Attachment 4

Amendment C203port (Planning Scheme Review): Summary of independent Planning Panel recommendations and officer response

Appendix 1: Annotated version of Heritage Policy with officer response

15.03-1L
 Proposed C203port

Figure 1 – Traditional locations for signage on heritage buildings

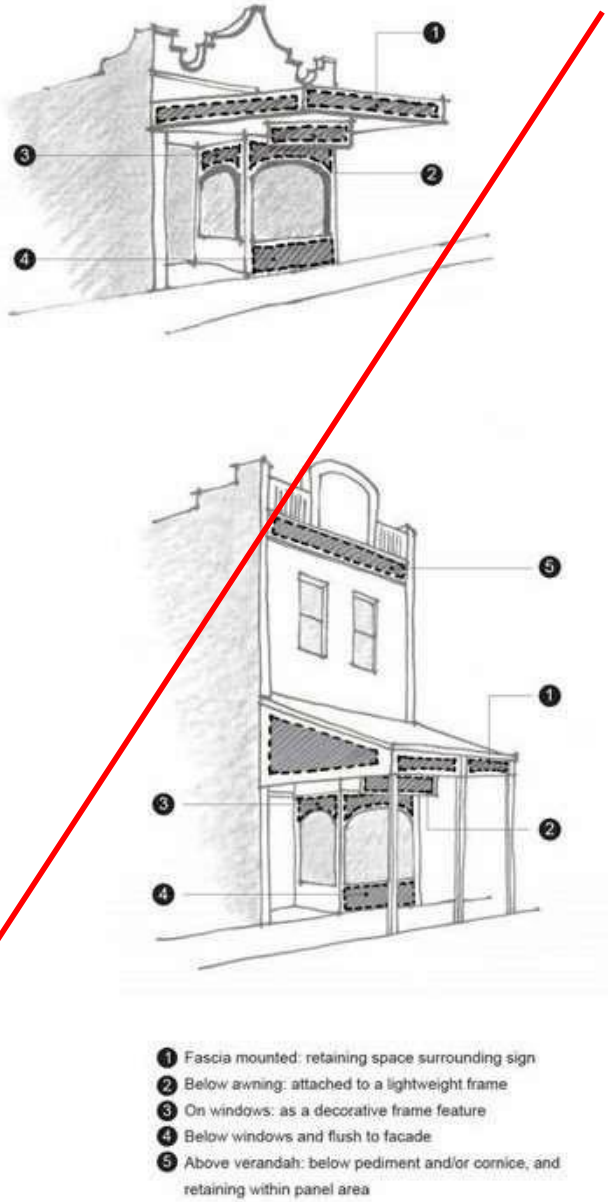
Commented [MB30]: Do not support – while these diagrams have come from the Heritage Design Guidelines (which have Panel support) retaining diagrams in the Heritage Policy is important for the community to continue to understand how signage strategies can be achieved without having to refer to background documents external to the Planning Scheme.

Commented [MB31]: Do not support – while these diagrams have come from the Heritage Design Guidelines (which have Panel support) retaining diagrams in the Heritage Policy is important for the community to continue to understand how signage strategies can be achieved without having to refer to background documents external to the Planning Scheme.

Figure 2 – Possible locations to conceal services and equipment

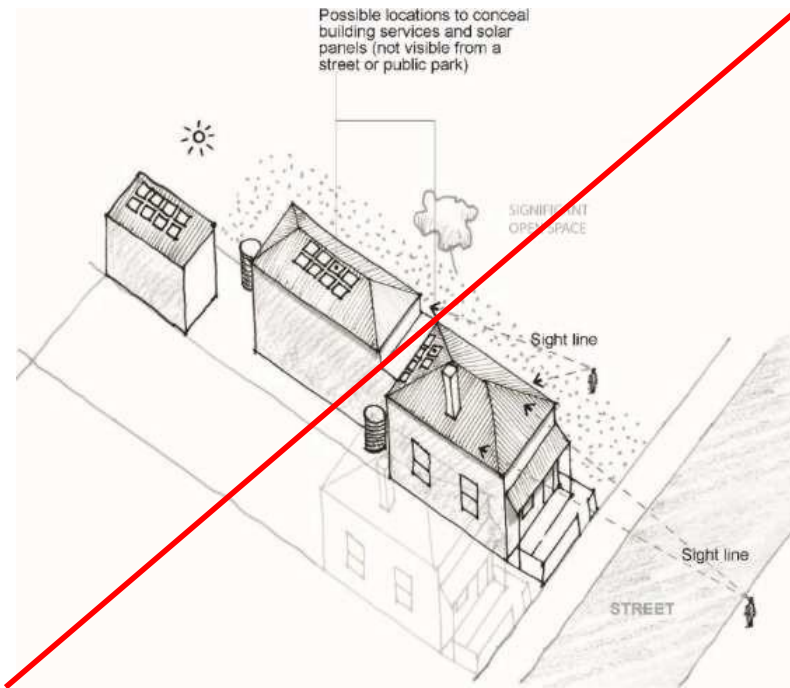
Commented [MB36]: Do not support – while these diagrams have come from the Heritage Design Guidelines (which have Panel support) retaining diagrams in the Heritage Policy is important for the community to continue to understand how signage strategies can be achieved without having to refer to background documents external to the Planning Scheme.

Commented [MB37]: Do not support – while these diagrams have come from the Heritage Design Guidelines (which have Panel support) retaining diagrams in the Heritage Policy is important for the community to continue to understand how signage strategies can be achieved without having to refer to background documents external to the Planning Scheme.

Figure 3—Sightline for an addition to a residential heritage place within a consistent heritage streetscape

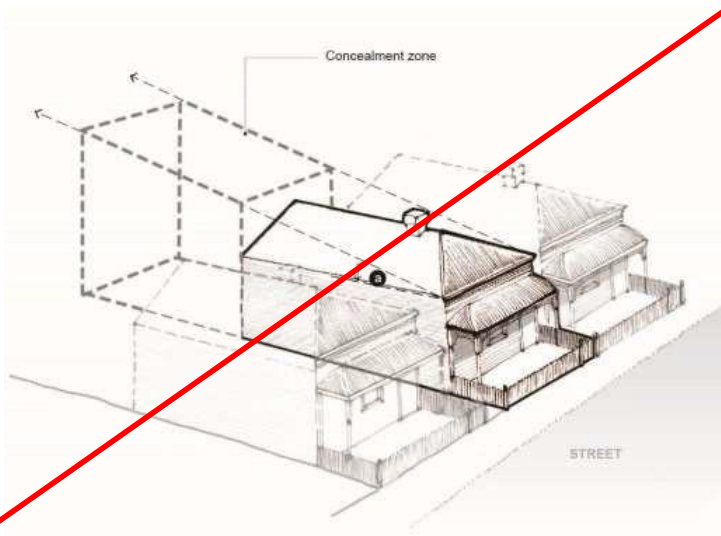
Commented [MB21]: Do not support – removes sightline provisions. Sightline provisions should be retained for the following reasons:

Commented [MB39]: Do not support – while these diagrams have come from the Heritage Design Guidelines (which have Panel support) retaining diagrams in the Heritage Policy is important for the community to continue to understand how signage strategies can be achieved without having to refer to background documents external to the Planning Scheme.

Figure 4– Sightline for an addition to a residential heritage place within a diverse streetscape

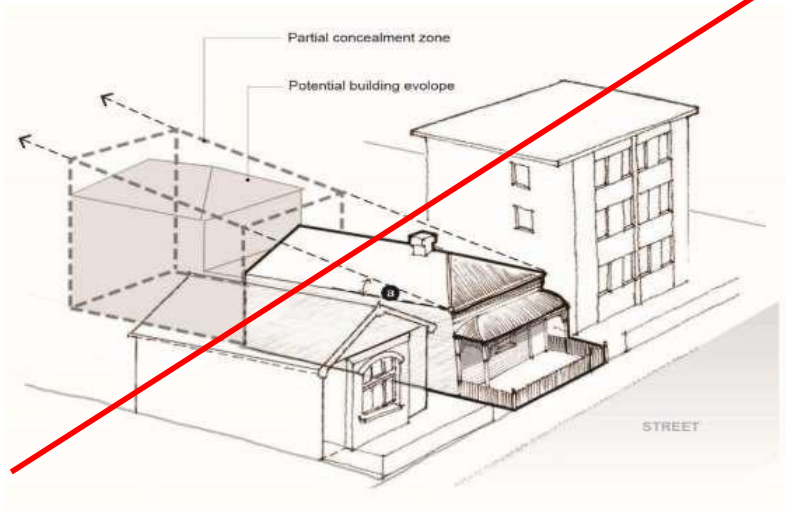
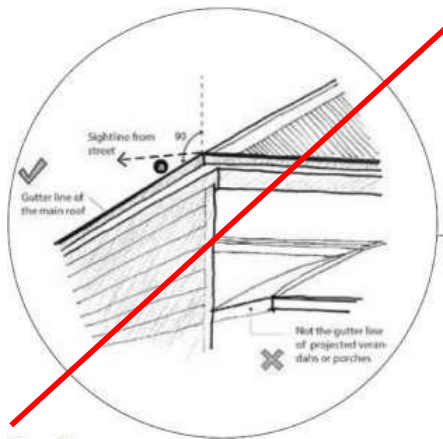
Commented [MB40]: Do not support – while these diagrams have come from the Heritage Design Guidelines (which have Panel support) retaining diagrams in the Heritage Policy is important for the community to continue to understand how signage strategies can be achieved without having to refer to background documents external to the Planning Scheme.

Commented [MB41]: Do not support – while these diagrams have come from the Heritage Design Guidelines (which have Panel support) retaining diagrams in the Heritage Policy is important for the community to continue to understand how signage strategies can be achieved without having to refer to background documents external to the Planning Scheme.

Figure 5 – Sightline for an addition to a residential heritage place in a narrow street

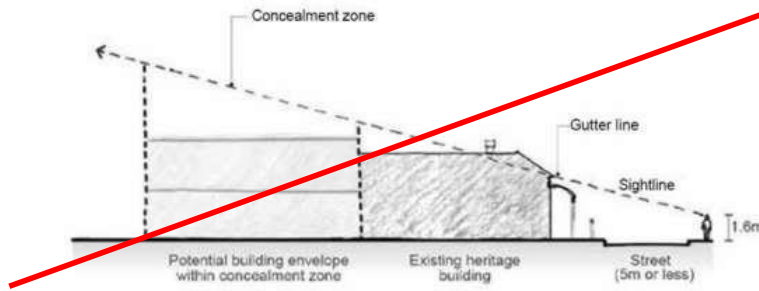
Commented [MB42]: Do not support – while these diagrams have come from the Heritage Design Guidelines (which have Panel support) retaining diagrams in the Heritage Policy is important for the community to continue to understand how signage strategies can be achieved without having to refer to background documents external to the Planning Scheme.

Figure 6 – Sightline for an addition to a residential heritage place with a primary ridge line parallel to the street

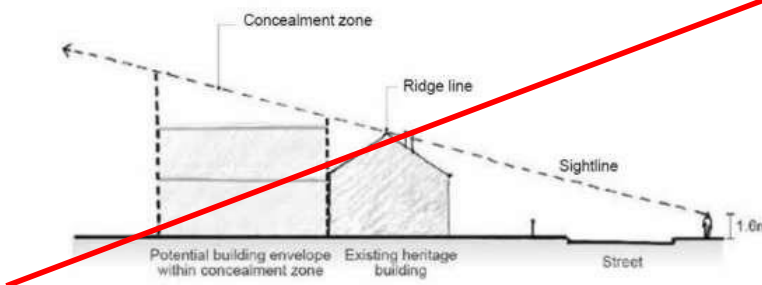
Commented [MB43]: Do not support – while these diagrams have come from the Heritage Design Guidelines (which have Panel support) retaining diagrams in the Heritage Policy is important for the community to continue to understand how signage strategies can be achieved without having to refer to background documents external to the Planning Scheme.

Figure 7 – Sightline for an addition to a commercial heritage place with a solid parapet

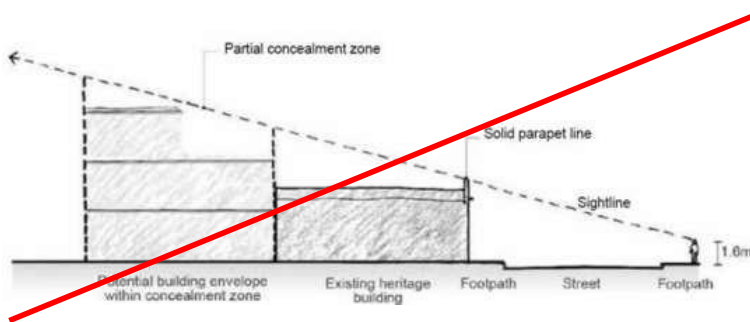
Commented [MB44]: Do not support – while these diagrams have come from the Heritage Design Guidelines (which have Panel support) retaining diagrams in the Heritage Policy is important for the community to continue to understand how signage strategies can be achieved without having to refer to background documents external to the Planning Scheme.

Figure 8 – Sightline for an addition to a two-storey commercial heritage place

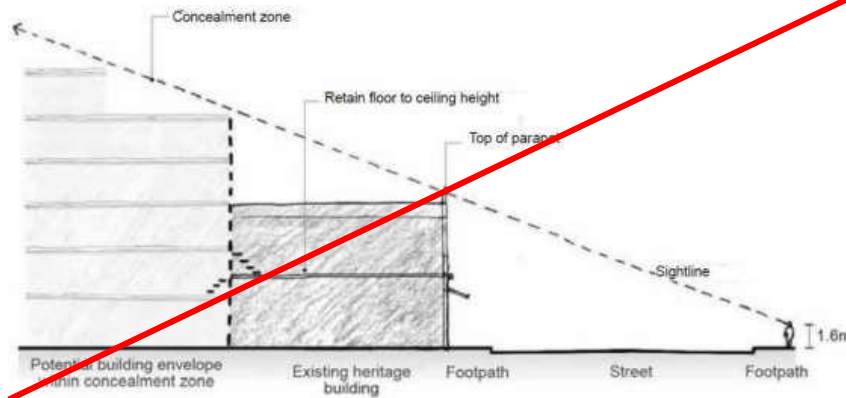
Commented [MB45]: Do not support – while these diagrams have come from the Heritage Design Guidelines (which have Panel support) retaining diagrams in the Heritage Policy is important for the community to continue to understand how signage strategies can be achieved without having to refer to background documents external to the Planning Scheme.
